**Chemung County Stormwater
Construction Inspection
Erosion and Sediment Control**

Project Name Hilliard Corporation	Date 6/27/2019
Location W. Clinton Street Elmira (City), NY	Permit # NYR11F218
Weather Conditions clear, warm	Entry Time: 8:39 am
On-Site Representative Present: Dale Dickerson-Elmira Structures	Exit Time: 8:58 am

PROJECT: Hilliard Corp. Expansion
City of Elmira
Municipal Construction Insp.
June 26, 2019

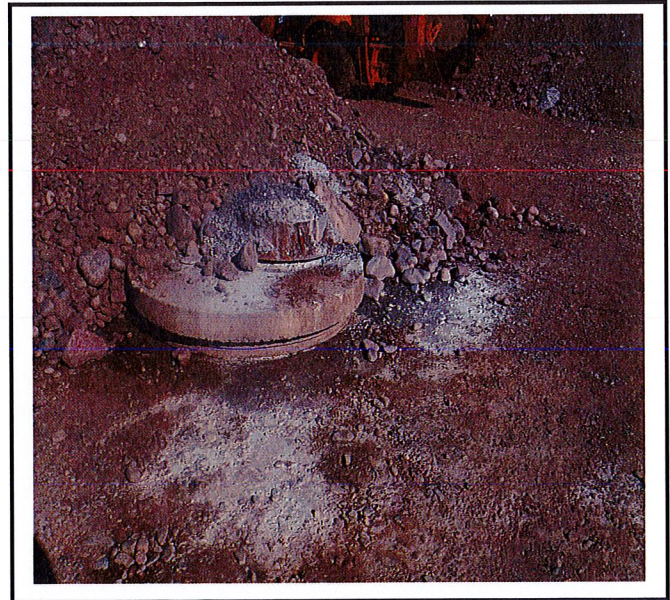
-Concrete trucks washed out on the ground and not into the concrete washout. Contractor said he discussed the issue with the driver at the time it occurred.

Concrete washed out onto the ground.
